**ADDENDUM 2****Addendum #** 2**Date Issued** January 27, 2026**Project Name | Job #** White Earth Withdrawal Management Facility | 20237410**Bid Date | Time** Tuesday, February 3, 2026 | 3:00 pm

THIS ADDENDUM AMENDS AND BECOMES PART OF THE CONTRACT DOCUMENTS FOR EAPC PROJECT 20245580 DATED 12/5/2025, RESPECTIVELY. EACH BIDDER SHALL ACKNOWLEDGE RECEIPT OF THIS ADDENDUM BY MARKING THE ADDENDUM NUMBER AND DATE ON THE BID FORM.

DRAWING TITLE
 BUILDING SECTIONS

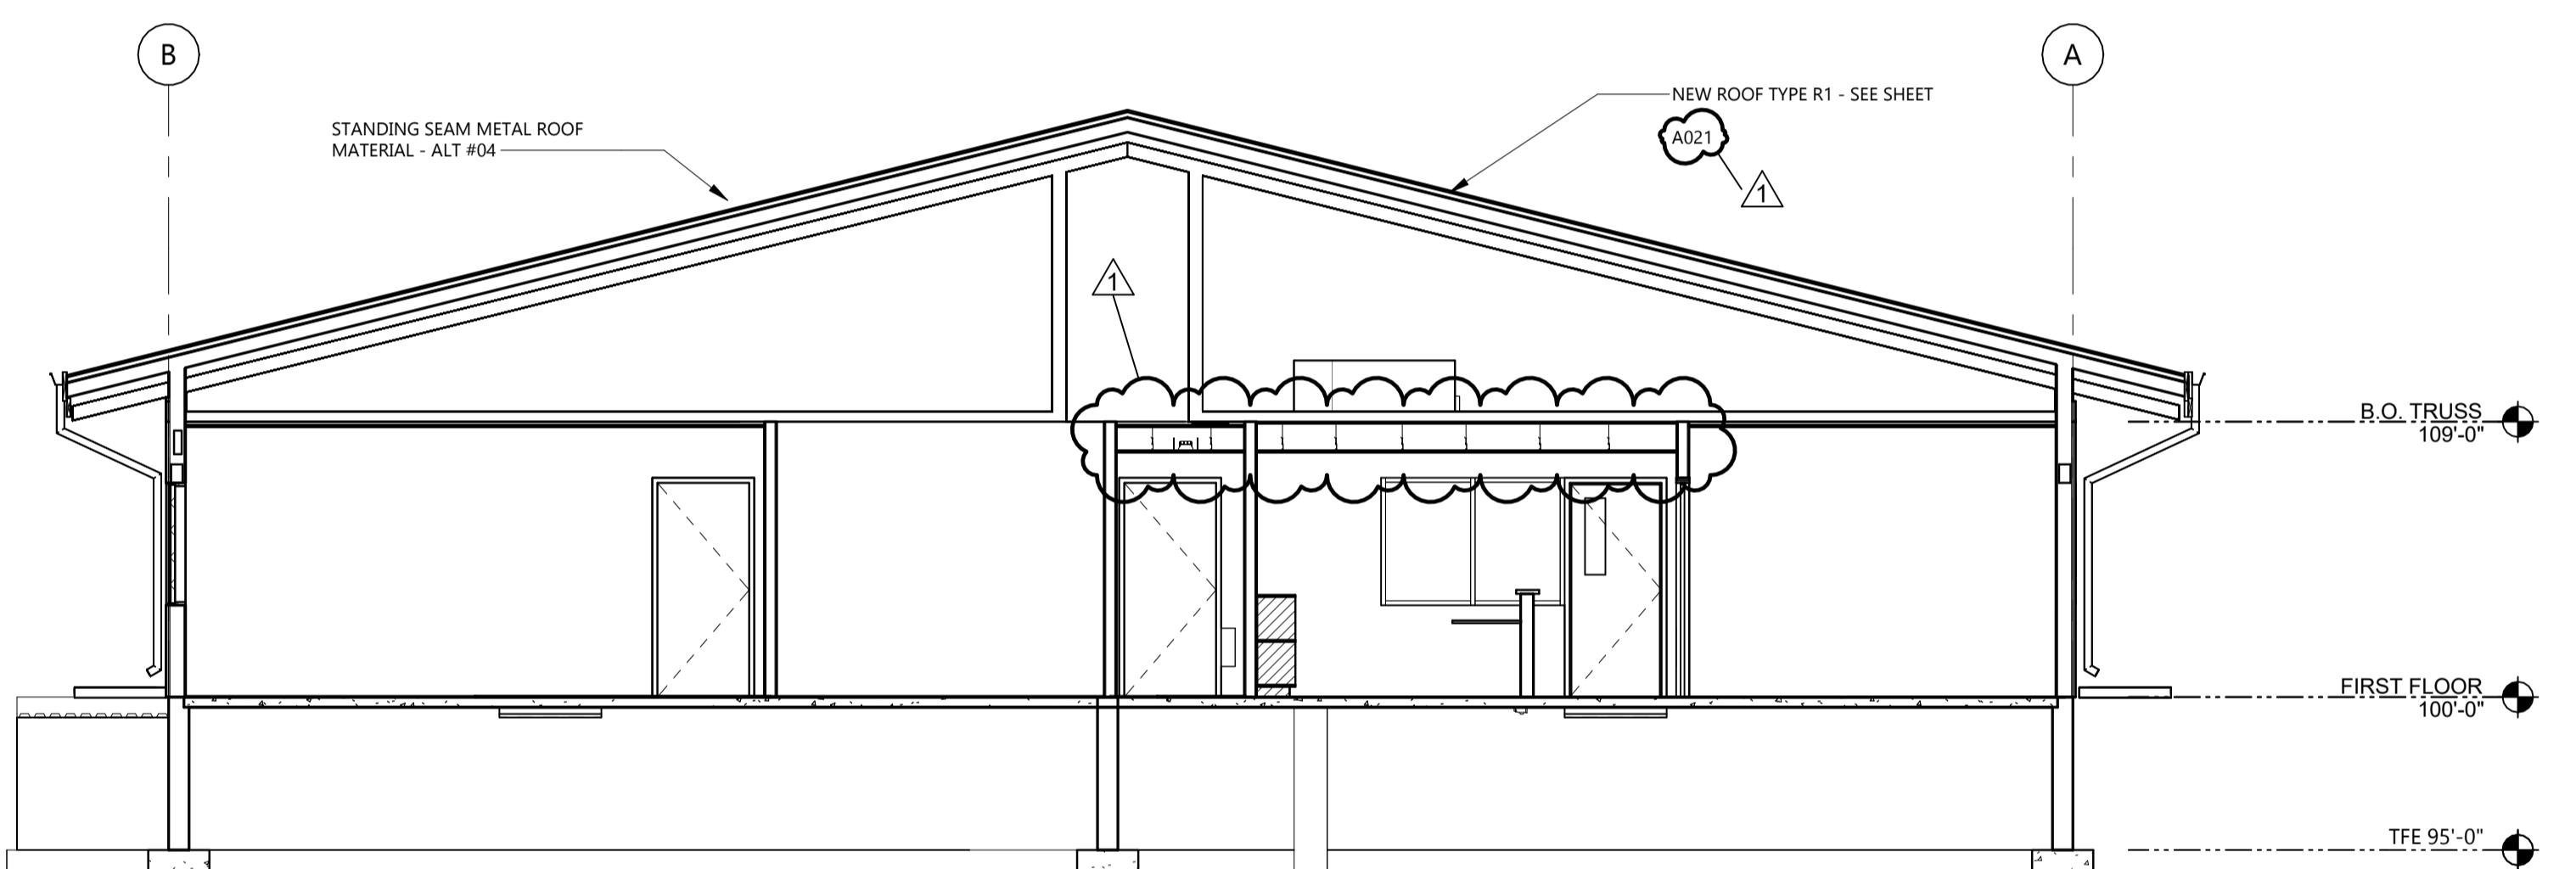
A421 Modify note to reference A021. Modify to show added dropped ceiling locations.

DRAWING TITLE
WALL SECTIONS
A441
SIDING BASE DETAIL @ BRICK VENEER

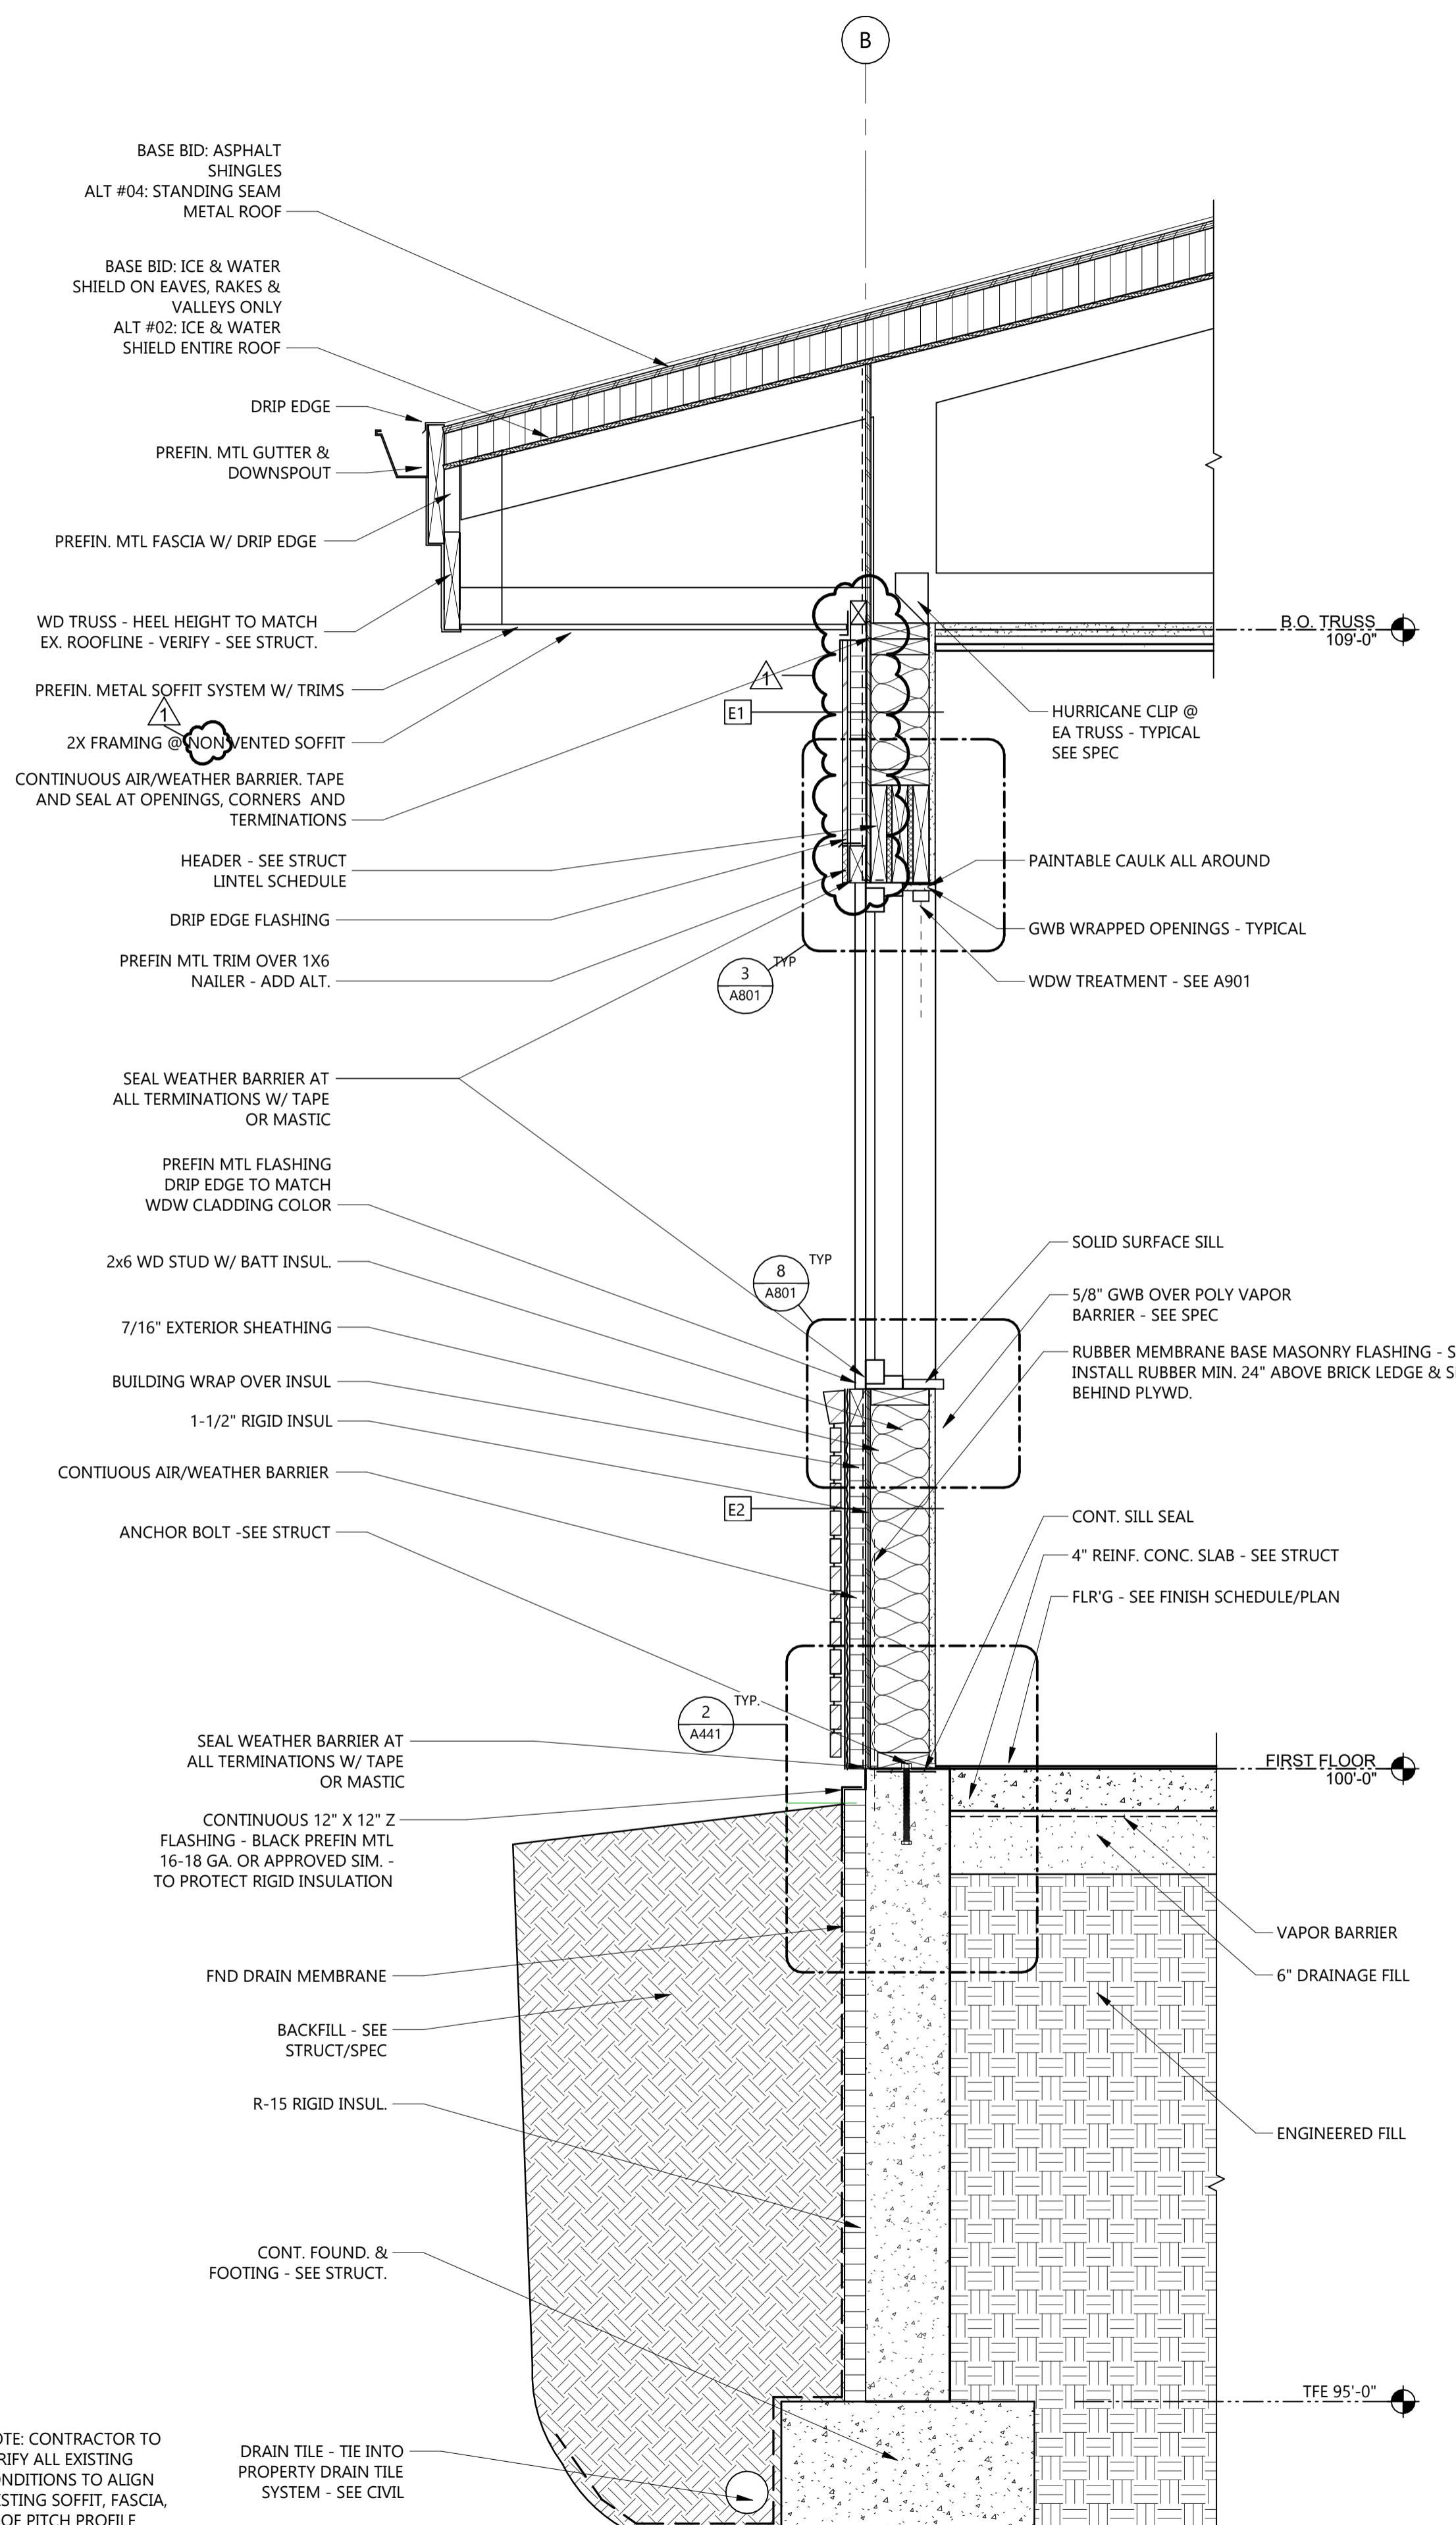
A441 Add note for foundation drain membrane at details 2/A441 and 3/A441. Modify soffit note 1/A441 to specify non vented soffits, typ.
